Work Order ID 161210

Item Name: Doubler

ENGINEERING CHANGE NOTICE NL 04510

DWG TITLE: SHEETMETAL

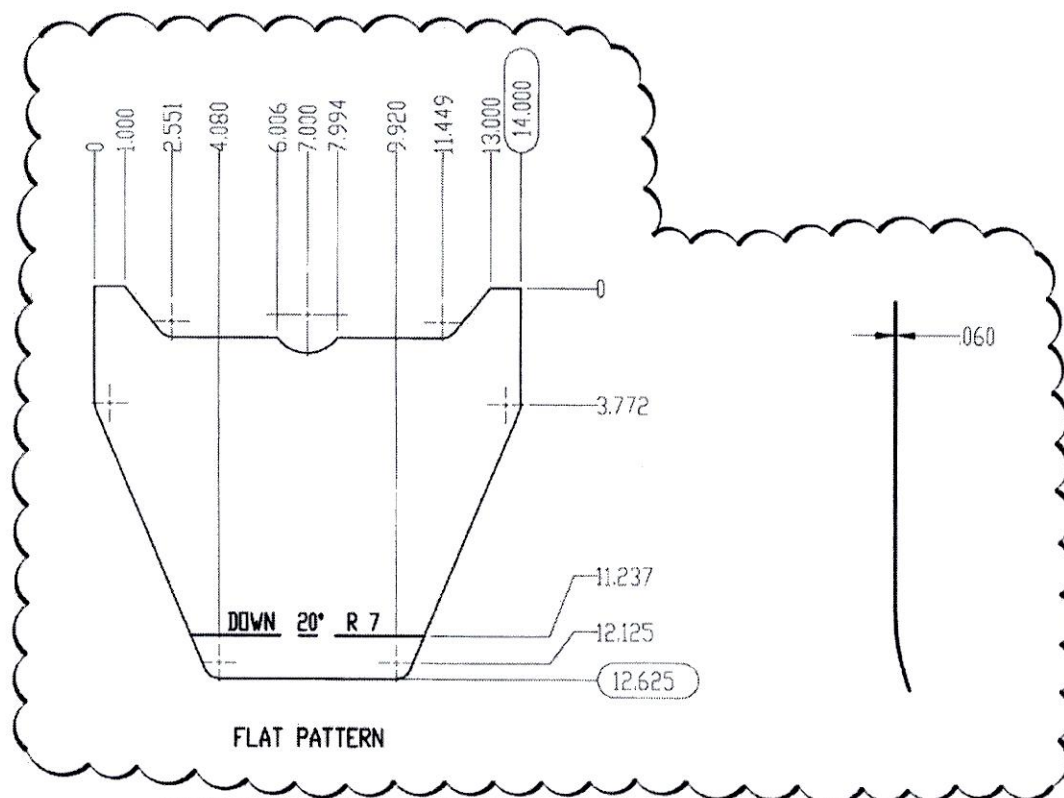
REASON: MODIFIED DOUBLER.

SHEET 1, ZONE C2 IS:

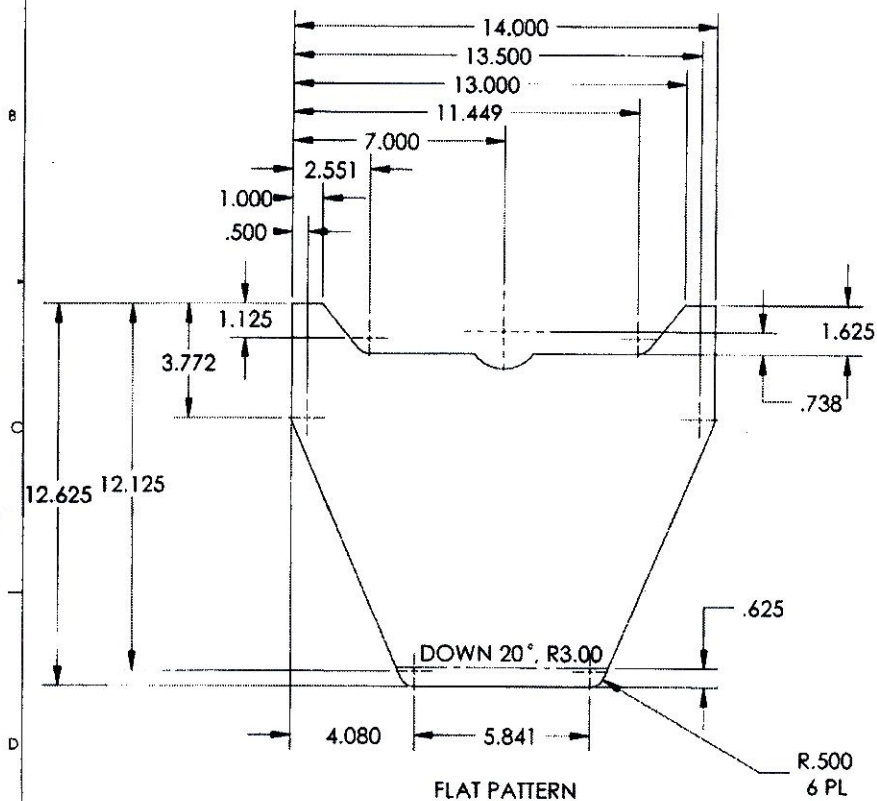
APICAL INDUSTRIES, INC.	ENGINEERING CHANGE NOTICE NO. 02866				SHEET 1 OF 1	
	DWG NO. 647.4100		REV: N/C	PREPARED BY R. ROSANO	DATE: 05/05/10	EFFECT ON DWG ☐ INC. ☒ UNINC.
	DWG TITLE: SHEET METAL					
	APPROVED BY: ENGR 	MFG 	QC 	EFF: CURRENT ORDER		
TRANSACTION CODES (TC): A-ADD C-CREATE R-REVISE D-DELETE	REASON: CHANGED PRETREATMENT CALLOUT

SHEET 1, ZONE A1 IS:

- 1. MATERIAL: ALUMINUM 2024-T3 PER AMS-QQ-A-250/4
- 2. FINISH: HARD ANODIZE IAW MIL-A-8625 TYPE II, CLASS 2, COLOR BLACK;
PRETREAT PR-148 ADHESION PROMOTER
PRIME IAW MIL-P-23377J TYPE I CLASS N
- 3. DEBURR AND BREAK ALL SHARP EDGES
- 4. IDENTIFY IAW MPP-120
